The Narragansett Electric Company
d/b/a Rhode Island Energy

Proposed FY 2026 Electric Infrastructure, Safety, and Reliability Plan

Responses to Division Data Requests
Sets 1 through 5

Docket No. 24-54-EL

Attachment 4 – Chart 5-Corrected
RI Reliability Performance CY 2013 – CY 2023
Regulatory Criteria (Excluding Major Event Days)

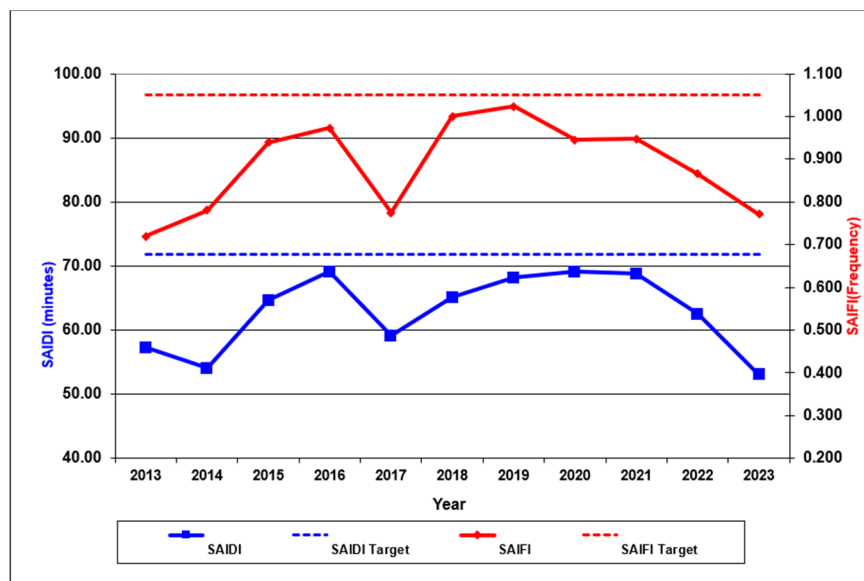
In executable format, please provide the underlying reliability data for:

- a. Attachment 4-Chart 1
- b. Attachment 4-Chart 2
- c. Attachment 4-Chart 5
- d. Attachment 4-Chart 6

Attachment 4 – Chart 5 in the FY26 ISR Plan Proposal has an error in the SAIDI data. The corrected chart is shown below.
